INTERNATIONAL PRELIMINARY EXAMINATION REPORT

Applicant GLL/ara		ent's file reference 7890	FOR FURTHER ACTION See Notification of Transmittal of International Preliminary Examination Report (Form PCT/IPEA/416)					
International application No. PCT/SG2003/000211			International filing date (day) 05.09.2003	month/year)	Priority date (day/month/year) 05.09.2003			
Internation A63B57		ent Classification (IPC) or bo	l oth national classification and II	PC				
Applicant E.T. LII

PCT/SG2003/000211

Figure 2e

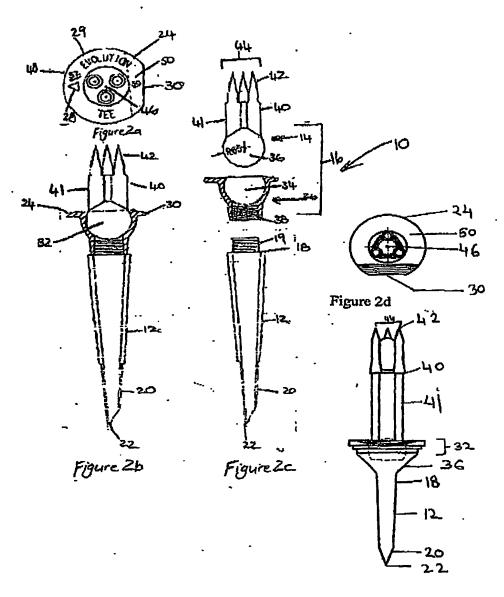
- 1. The applicant has introduced entirely new figures 2d, 2e, 3d, 3e, 4d, 4e and 5, has made amendments on replacement pages 1, 2, 2A, 2B and 3 of the description, and has provided a set of amended claims 1-21, on replacement pages 11-14.

- 1.1 The information content of the introduced drawings extends beyond the content of the application as filed, contrary to Article 34(2)(b) PCT. The original description is not considered to provide a sufficient basis for the added drawings. Therefore the amendments to the drawings (along with the amendments to the list of drawings on replacement pages 2B and 3) were not taken into account.
